NEW YORK STATE THRUWAY AUTHORITY
DEPARTMENT OF ENGINEERING

AMENDMENT NO. 1
TO

CONTRACT TAA 25-6B
D215009
REHABILITATION OF NYS THRUWAY (I-90)
BRIDGE OVER NYS ROUTE 5S / ERIE
CANAL RAIL TRAIL
AT MILEPOST 178.38
IN THE ALBANY DIVISION
IN MONTGOMERY COUNTY

| TITLE OF DRAWING GENERAL NOTES (SHEET 2 OF 2) | DRAWING NUMBER: GNN-2 | |

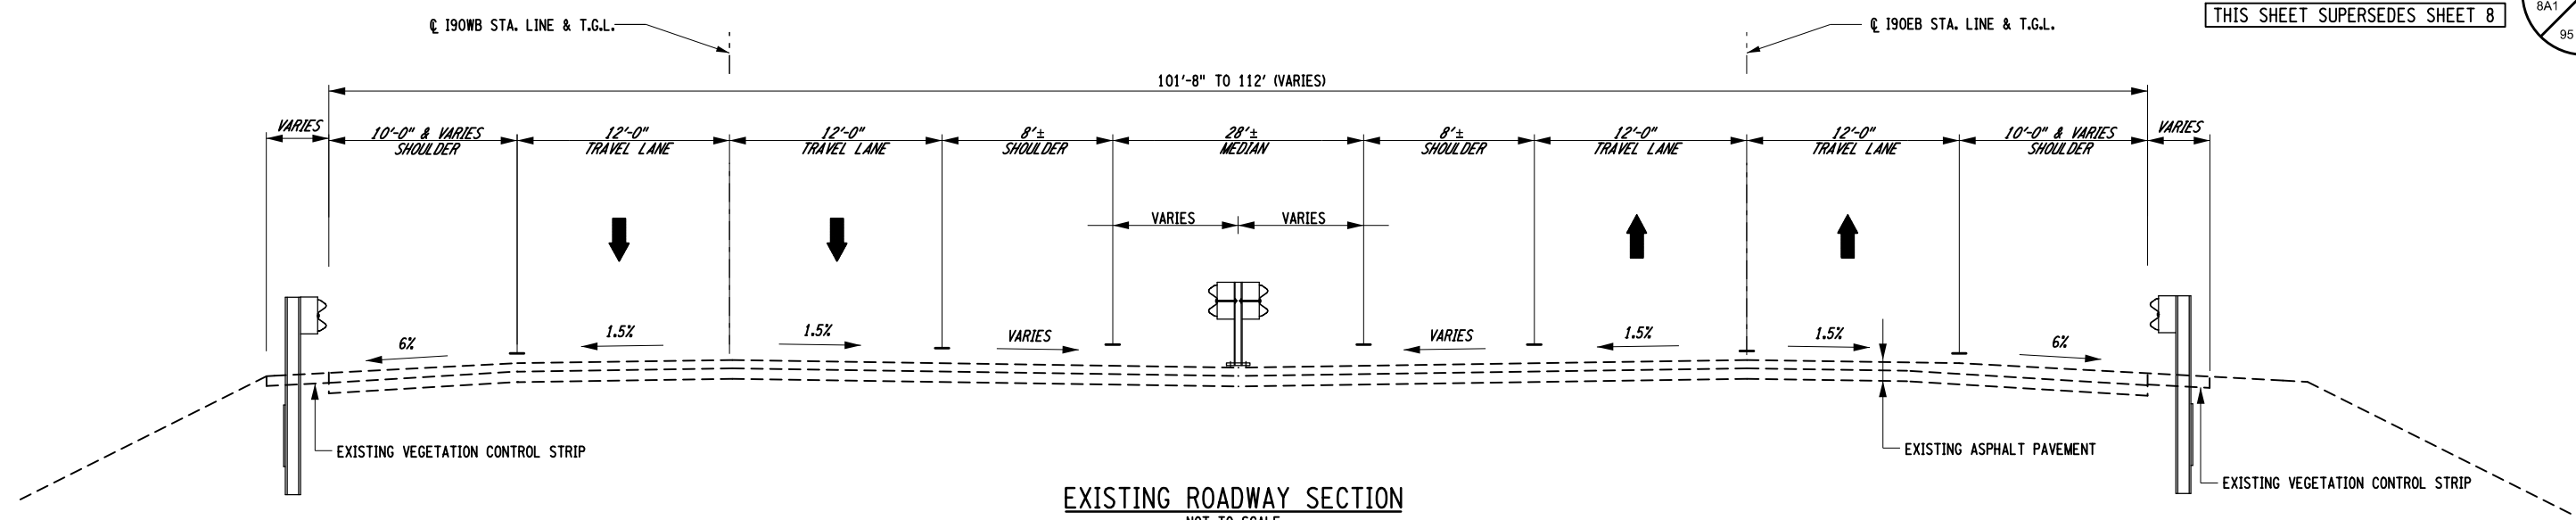
6. **DELETE** Drawing Number GNN-2, Sheet 7 of 95 and **SUBSTITUTE** with the attached Drawing Number GNN-2, Sheet 7-A1 of 95. Painting Note 11 a. was removed to eliminate the finish paint coat requirement on new galvanized steel and Note 11 b. was modified to not limit the definition of "Critical Area" and reference a typical girder painting detail on ST-29.

b. EXISTING STEEL WITHIN THE "CRITICAL AREA" AS DEFINED IN THE SPECIFICATION ARE TO BE CLEANED AND PAINTED UNDER ITEM 574.9403--25. FINISH COAT COLOR SHALL MATCH THE EXISTING BRIDGE PAINT. VIEWING SHALL BE DONE UNDER NORTHERN STANDARD DAYLIGHT. SEE DWG. NO. ST-29 FOR A DETAIL OF THE TYPICAL GIRDER PAINTING LIMITS.

| TITLE OF DRAWING TYPICAL SECTION (SHEET 1 OF 3) | DRAWING NUMBER: TYP-01 |

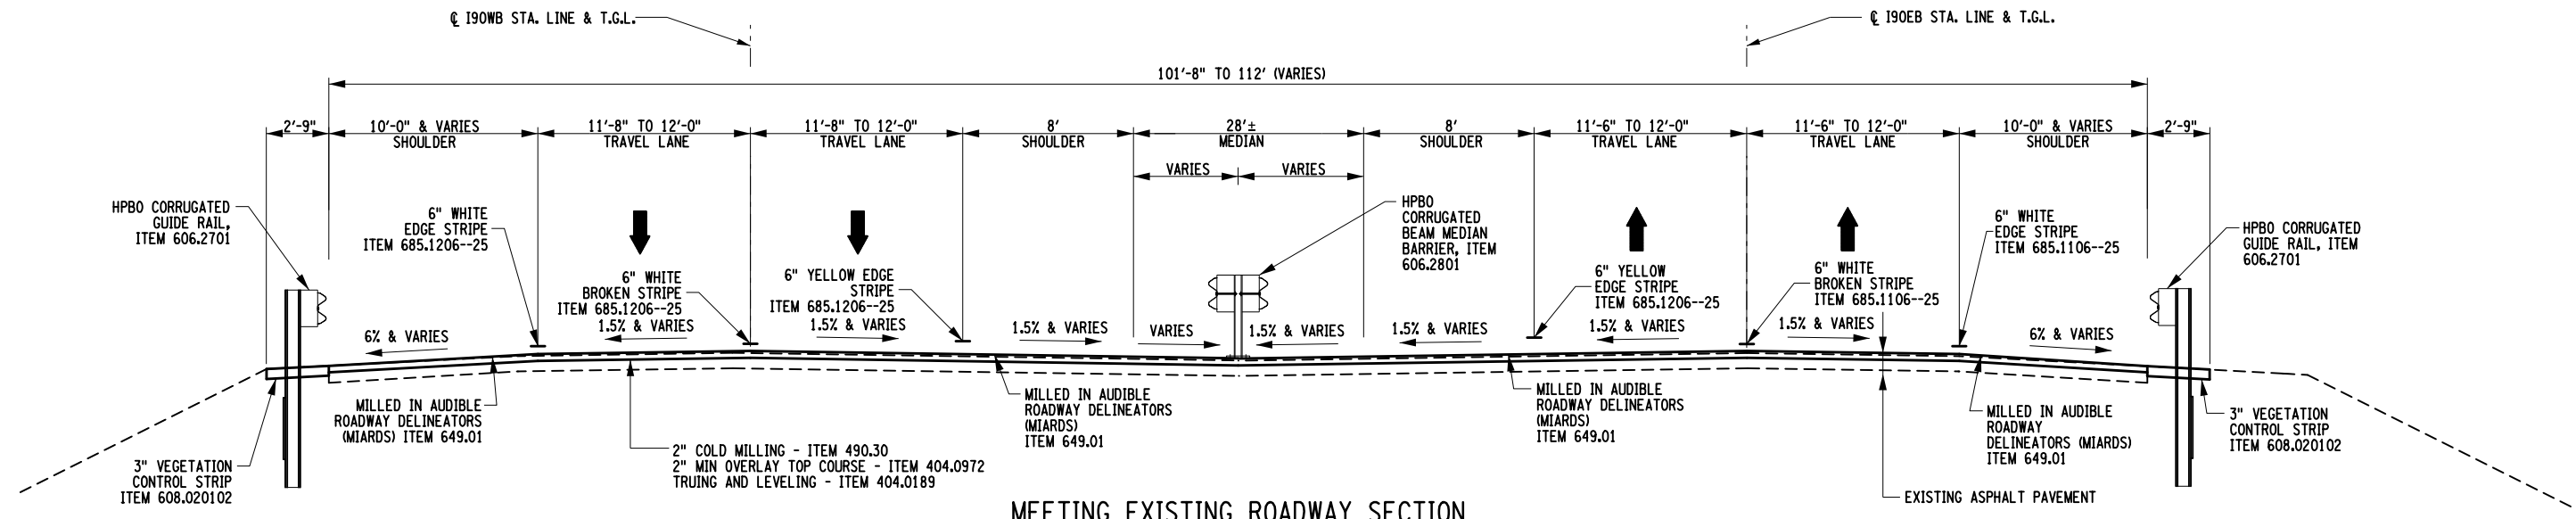
7. **DELETE** Drawing Number TYP-01, sheet 8 of 95, and **SUBSTITUTE** with the attached Drawing Number TYP-01, Sheet 8-A1 of 95. Item 404.0189 Truing & Leveling F9 Asphalt, 80 Series Compaction has been added to the contract to fill in voids and establish proper profile and grade.

| TITLE OF DRAWING TYPICAL SECTION (SHEET 2 OF 3) | DRAWING NUMBER: TYP-02 |

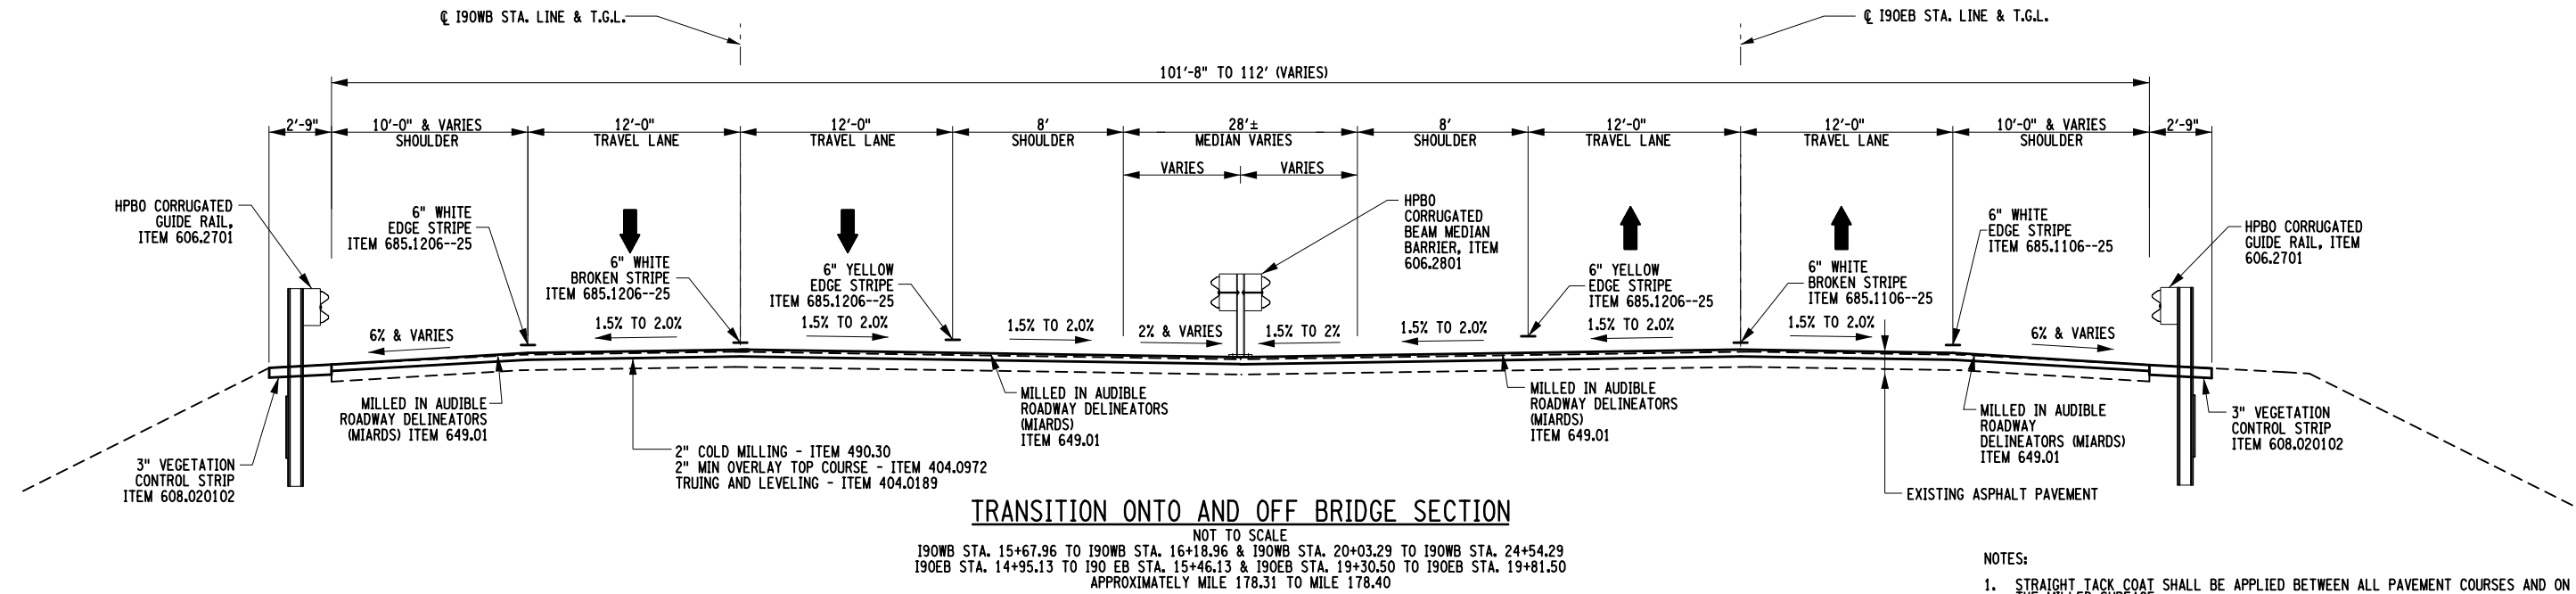
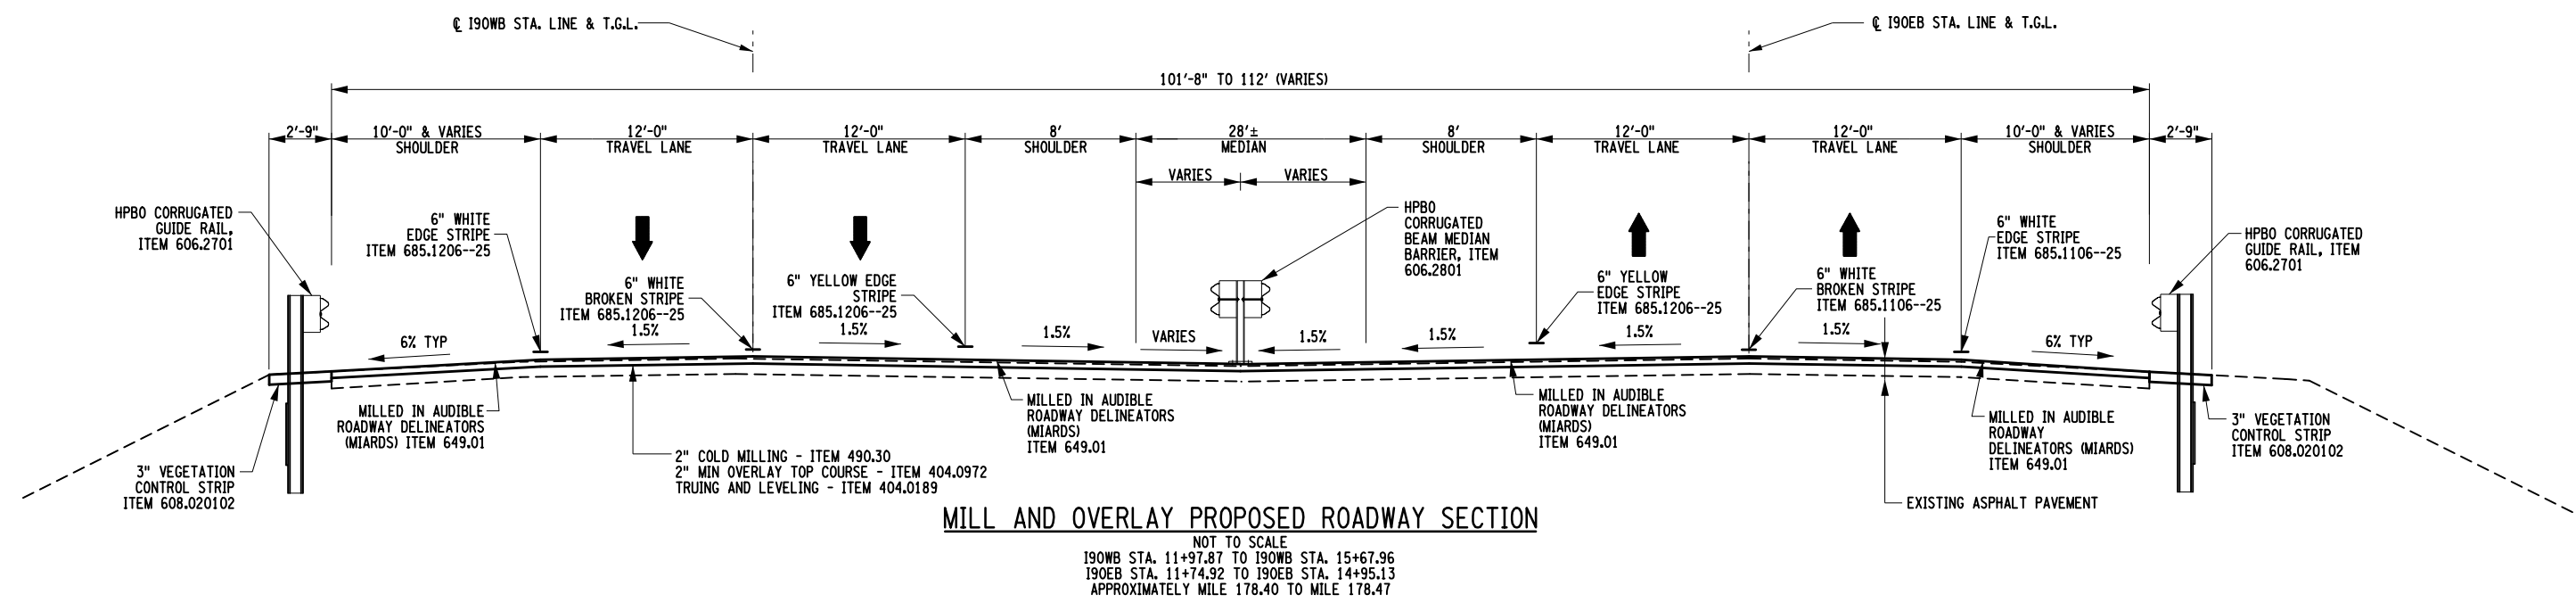
8. **DELETE** Drawing Number TYP-02, sheet 9 of 95, and **SUBSTITUTE** with the attached Drawing Number TYP-02, Sheet 9-A1 of 95. Item 404.0189 Truing & Leveling F9 Asphalt, 80 Series Compaction has been added to the contract to fill in voids and establish proper profile and grade.

| TITLE OF DRAWING TYPICAL SECTION (SHEET 3 OF 3) | DRAWING NUMBER: TYP-03 |

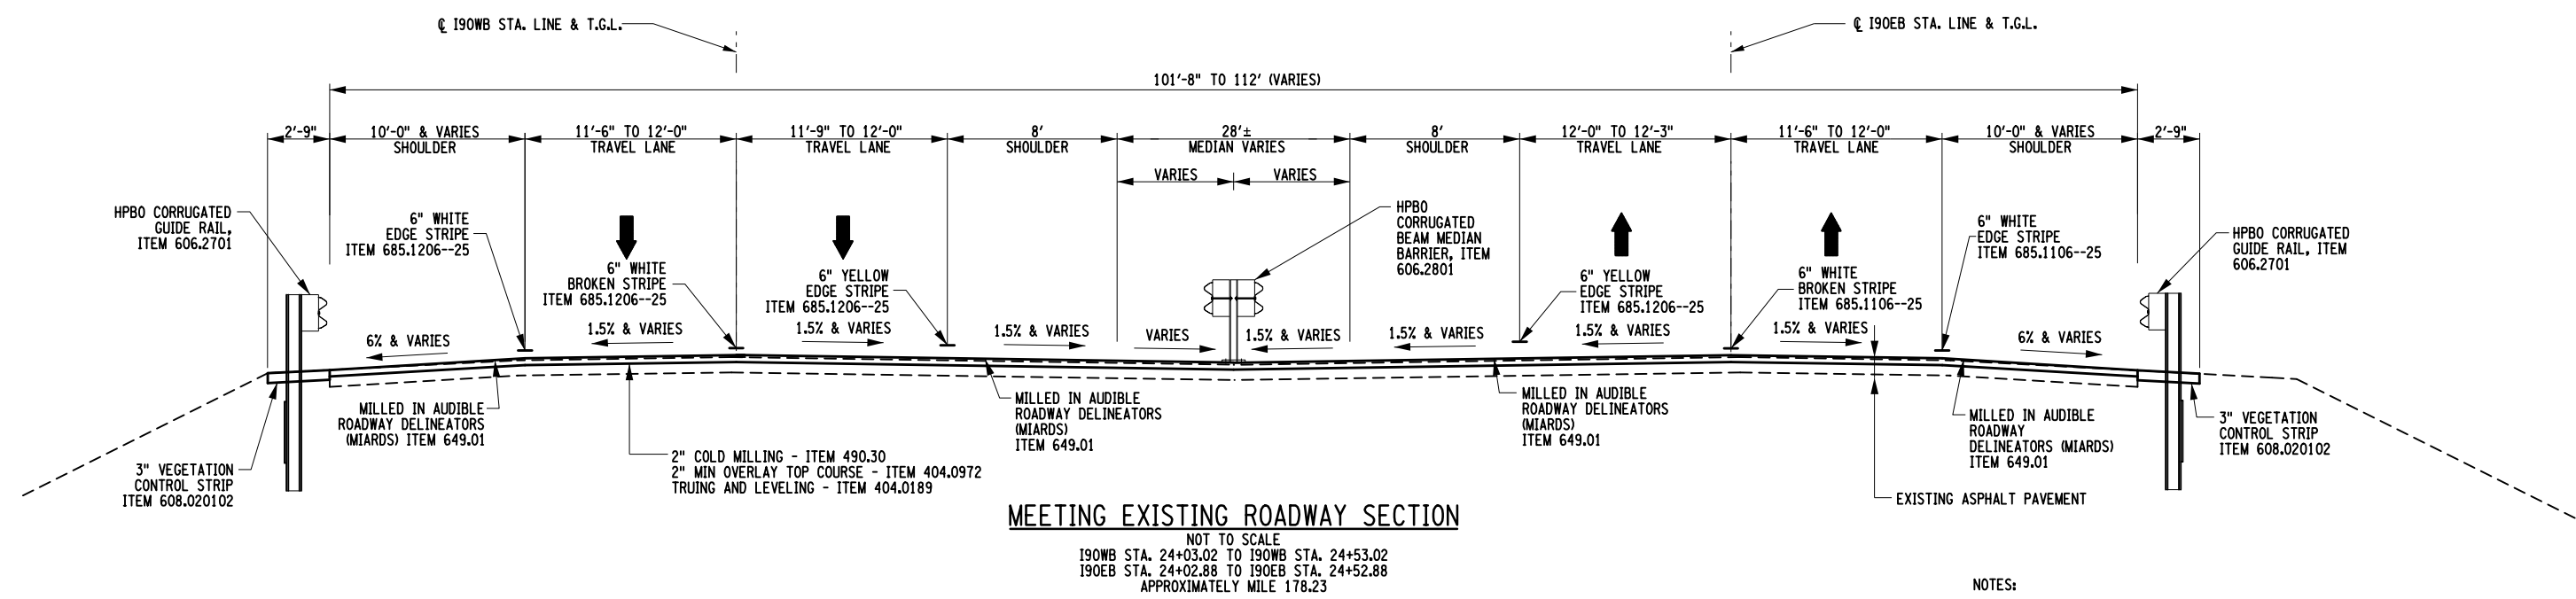
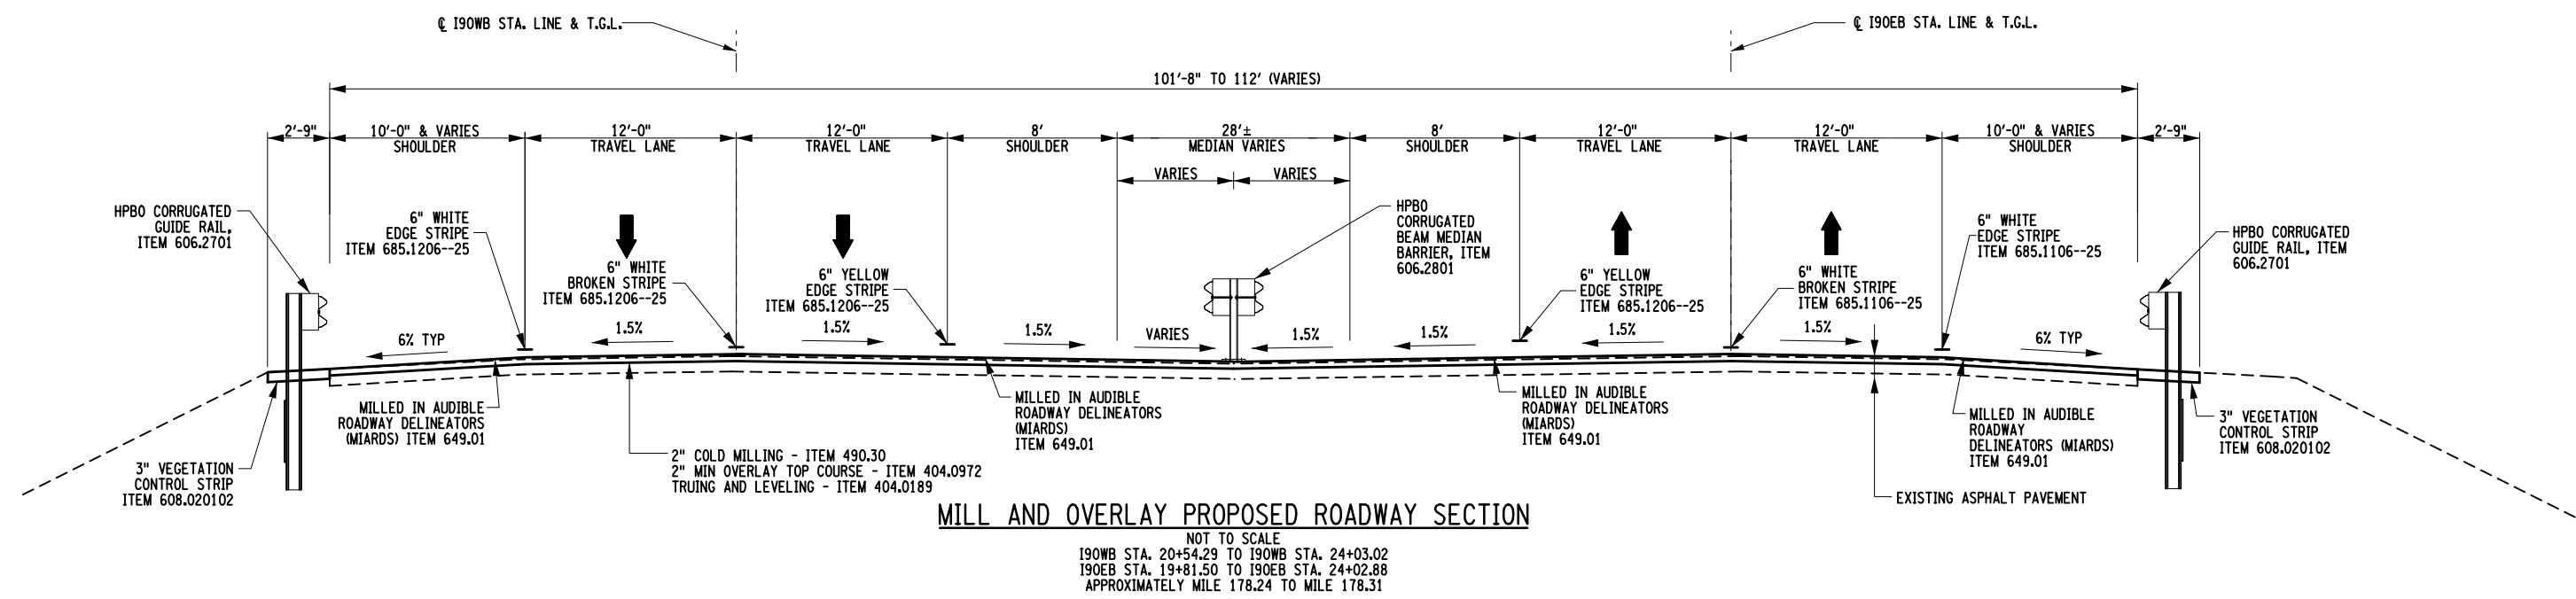
9. **DELETE** Drawing Number TYP-03, sheet 10 of 95, and **SUBSTITUTE** with the attached Drawing Number TYP-03, Sheet 10-A1 of 95. Item 404.0189 Truing & Leveling F9 Asphalt, 80 Series Compaction has been added to the contract to fill in voids and establish proper profile and grade.
